OIL CONSERVATION COMMISSION

OIL CONSERVATION COMMISSION BOX 871	RE:
SANTA FE, NEW MEXICO	PROPOSED NSP <u>161</u>
	PROPOSED NSL
Dear Mr. Macey:	
I have examined the application	1 dated 5/26
for the Continental Farney A-	
Cperator	Lease and Well No. S-T-R
and my recommendations are as f	
40 acre allowable-Wells 4 and 5 completed in same strata as oil well	
top allowables- RFM	
	creage. Recommend this case for a hearin
	creage. Recommend this case for a hearin
	creage. Recommend this case for a hearin Yours very truly,
Simultaneous dedication of ac	creage. Recommend this case for a hearin
Simultaneous dedication of ac	creage. Recommend this case for a hearin Yours very truly,
Simultaneous dedication of ac	creage. Recommend this case for a hearin Yours very truly, OIL CONSERVATION COMMISSION Stanley J. Stanley
Simultaneous dedication of ac	creage. Recommend this case for a hearin Yours very truly, OIL CONSERVATION COMMISSION
Simultaneous dedication of ac	creage. Recommend this case for a hearin Yours very truly, OIL CONSERVATION COMMISSION Stanley J. Stanley

Continental Oil Company respectfully requests administrative approval under the provisions of Rule 5 (b) of Order No. R-520 for

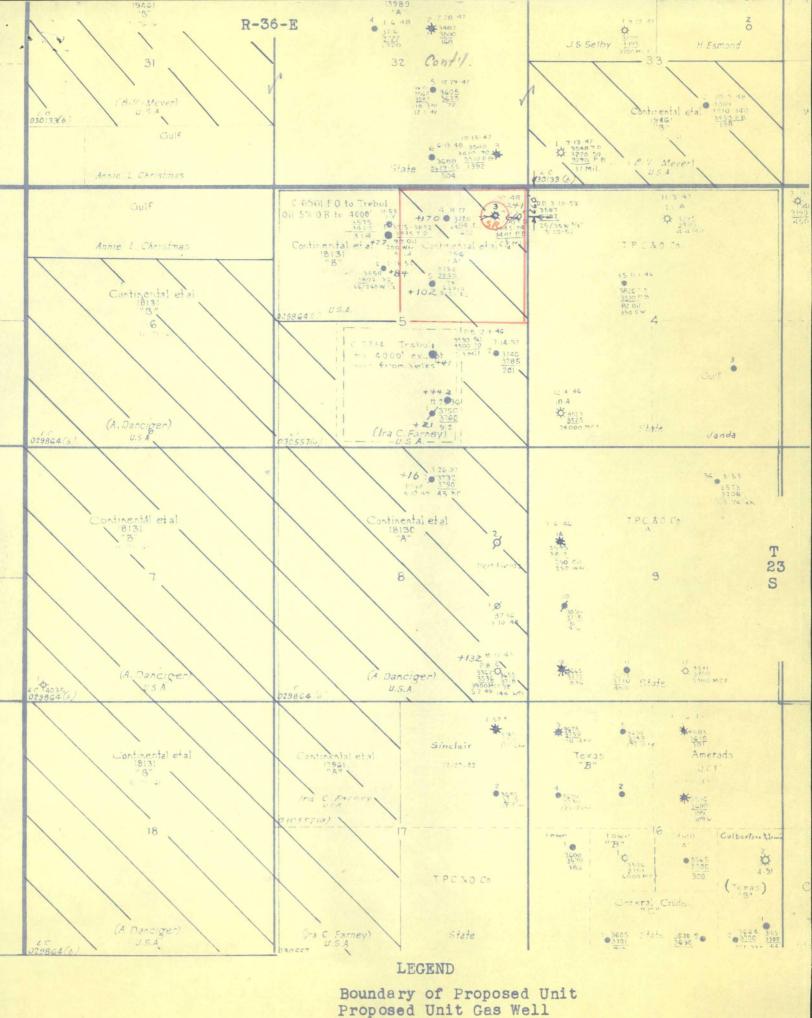
Simultaneous dedication of ac	creage. Recommend this case for a hearin Yours very truly, OIL CONSERVATION COMMISSION Stanley J. Stanley
